H. B. ROBINSON STEAM ELECTRIC PLANT, UNIT NO. 2

AMENDMENT TO FACILITY OPERATING LICENSE

Amendment No. 71  
License No. DPR-23

ATTACHMENT TO LICENSE AMENDMENT

FIGURE 3.10-1

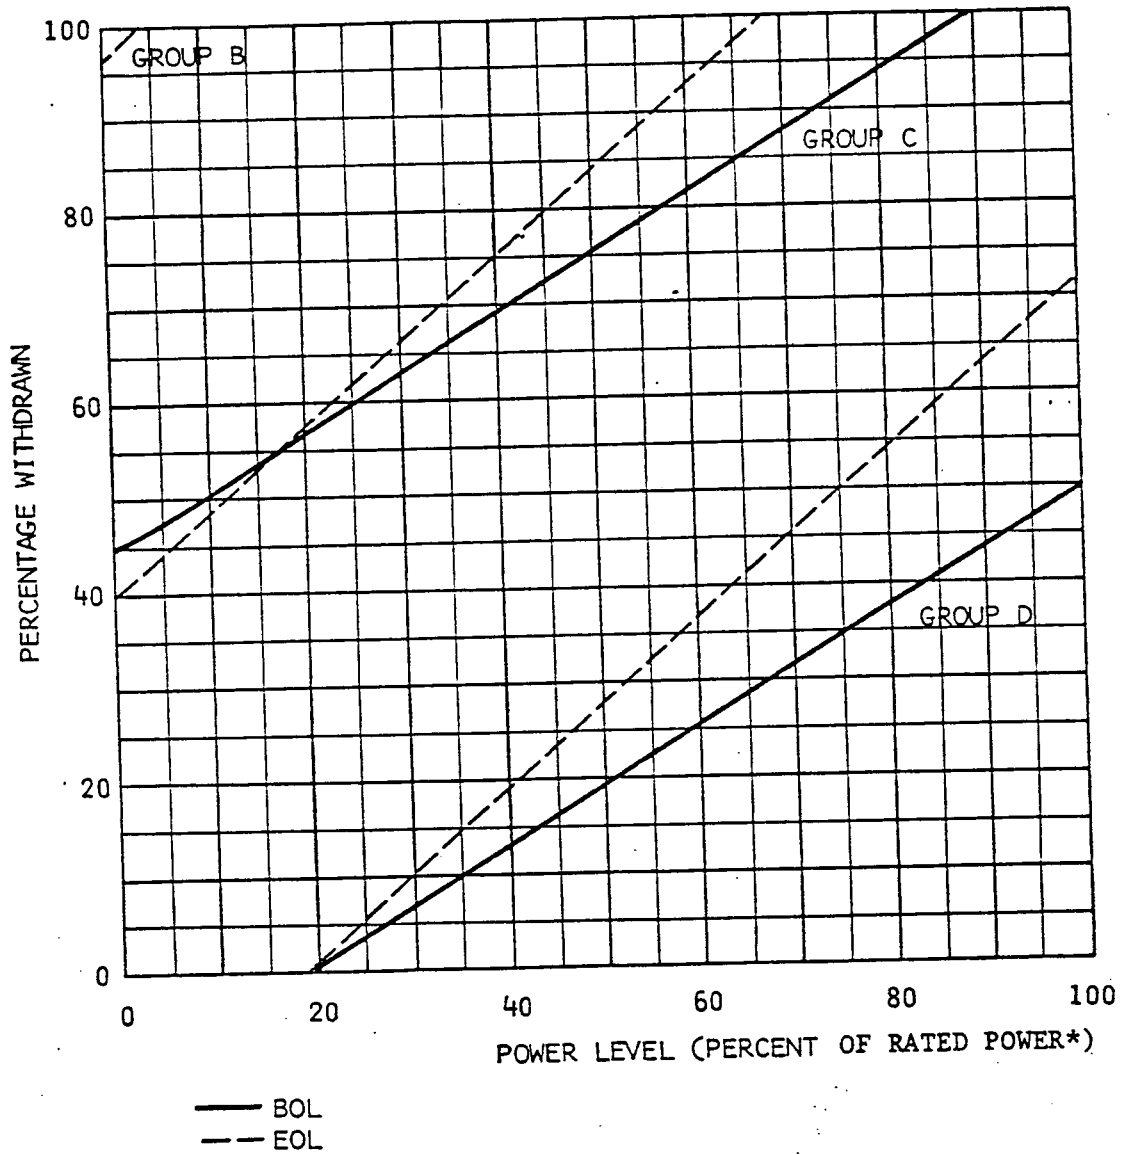
CONTROL GROUP INSERTION LIMITS FOR  
THREE LOOP OPERATION

\*Rated Power is defined here as 2300 Mwt under the normal  $T_{avg}$  program and 1955 Mwt under the reduced  $T_{avg}$  program.
